From: Raymond C. Vaughan, Ph.D., P.G.
To: Sierra Club Atlantic Chapter
Subject: Hakes FSEIS does not rebut the evidence presented by Sierra Club
Date: February 21, 2019

This memorandum addresses the points made regarding radioactivity issues in the responses to public comments by both the NYS Department of Environmental Conservation (DEC) and the Town of Campbell in the Final Supplemental Environmental Impact Statement for the Hakes C&D Disposal - Landfill Expansion Project, dated December 5, 2018 (the “FSEIS”). The responses of the Town of Campbell include a report prepared for the town by Theodore E. Rahon, Ph.D., Certified Health Physicist, CoPhysics Corporation, titled *Report: A Review of Drill Cuttings Disposal at the Hakes C&D Landfill and Response to Public Comment*, dated May 16, 2018, and attached to the Town of Campbell response to comments, Appendix 5 to the FSEIS (the “CoPhysics Report”). Responses from both DEC and CoPhysics are addressed here. The Town of Campbell has not provided independent responses on radioactivity issues but, instead, has referred to the DEC and CoPhysics responses.

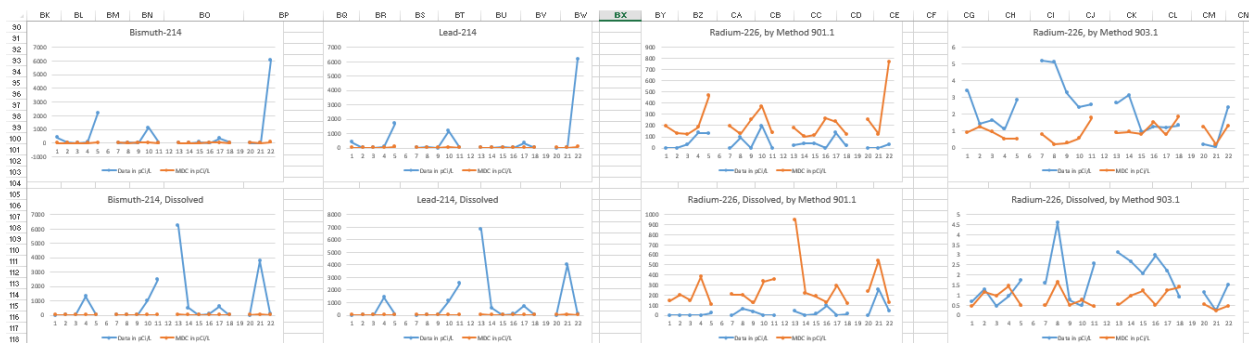
In fact, the Hakes leachate test results for Lead-214 and Bismuth-214 are *intermittently very high*, ranging far beyond 50 pCi/L to about 6000 pCi/L. These strange and unexplained test results create a justified concern that substantial amounts of the radium-bearing waste brought into the landfill have exceeded the 25 pCi/g regulatory limit. The scientific basis for this concern has been set forth in my affidavit of January 18, 2018, my presentation of February 10, 2018, and the Sierra Club comment letter dated March 19, 2018.

The following figures from my January 18, 2018 affidavit show the intermittently high levels of Lead-214 and Bismuth-214 in the leachate, ranging up to ~6000 pCi/L, and the substantially lower levels of Radium-226 in the leachate, as reported in the semiannual test results for these three radionuclides.² Similar results, ranging up to ~1000 pCi/L, are shown by the data from the Chemung County landfill leachate tests. These results are included here because they illustrate that another landfill that has taken high levels of drill cuttings and other gas drilling wastes also manifests intermittently high levels of Lead-214 and Bismuth-214 in leachate.

For Chemung County Landfill:

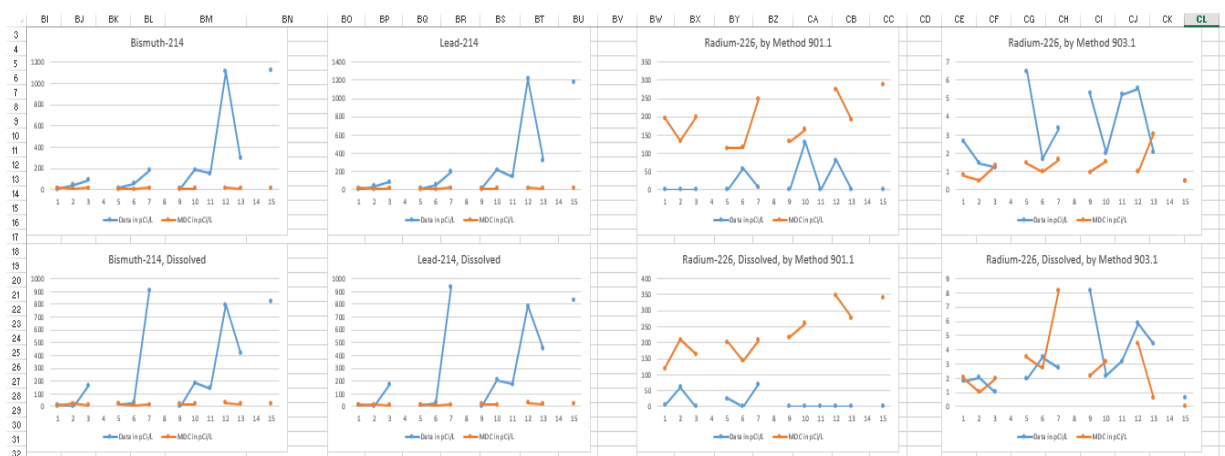
- 1-3 are the 2015-2017 time trend for Leachate Pond (Combined Leachate)
- 5-7 are the 2015-2017 time trend for Cells I through III Primary Leachate
- 9-13 are the 2015-2017 time trend for Cell IV Primary Leachate
- 15 is the single data point for the 2017 measurement of Cell V Primary Leachate.

In summary, the above graphs show that the test results (blue lines) for Bismuth-214 and Lead-214 are intermittently very high, ranging up to about 6000 pCi/L in Hakes leachate and 1000 pCi/L in Chemung leachate, while the test results (blue lines) for radium in Hakes and Chemung leachate remain much lower.
